BSC ISI Flexure Attachment Design

Kick-off Meeting

LIGO-G0900292-v2

Current Design

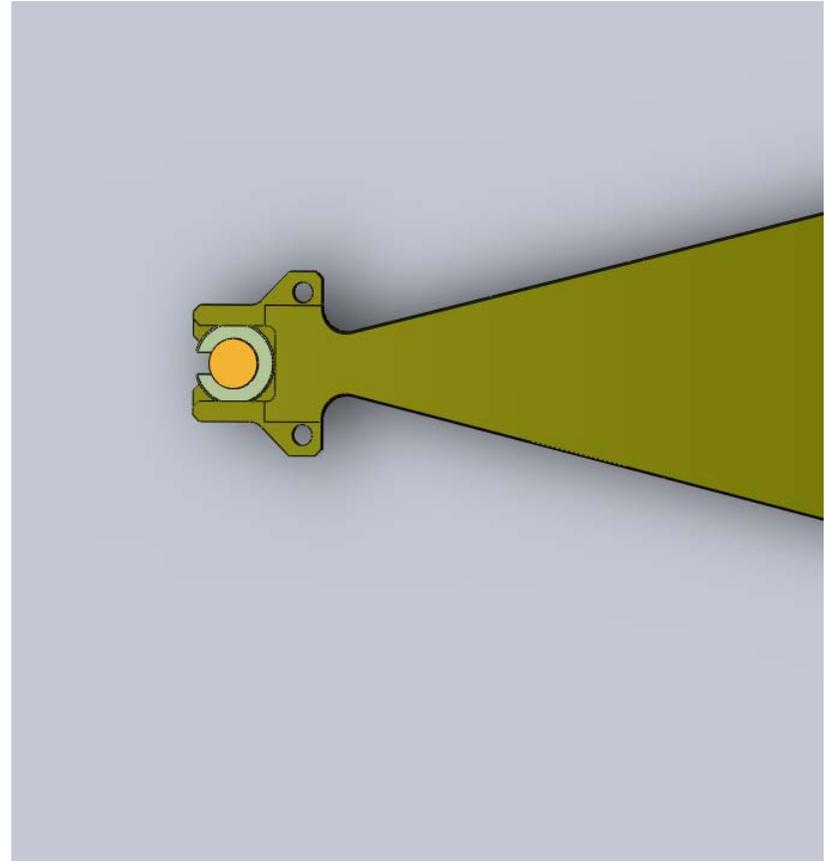
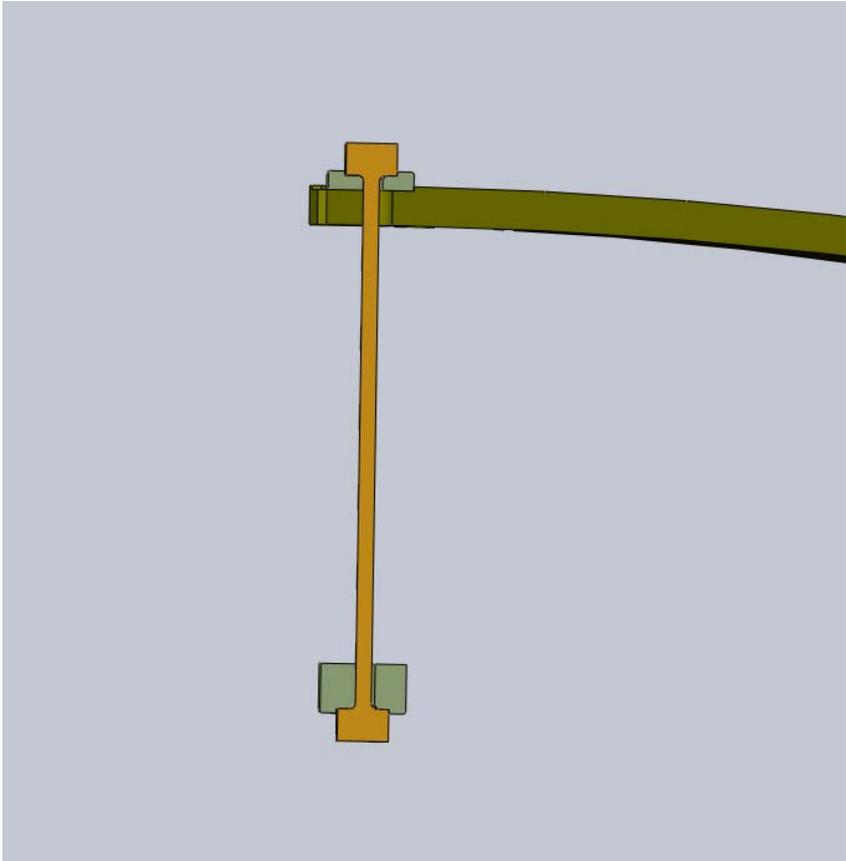
30 The flexure rod with the shim attached should sit more securely in the spring cut out; the design should avoid misplacement during installation and shouldn't allow any movement later on-- more than friction should hold these shims in place against the spring

17 Tooling to hold this rod perpendicular to the top of the bracket to make sure flexure rod is straight as the spring is released onto the flexure rod would be helpful in aligning the flexure rod-- currently using parallels and trying to eyeball whether the flexure rod is straight up and down
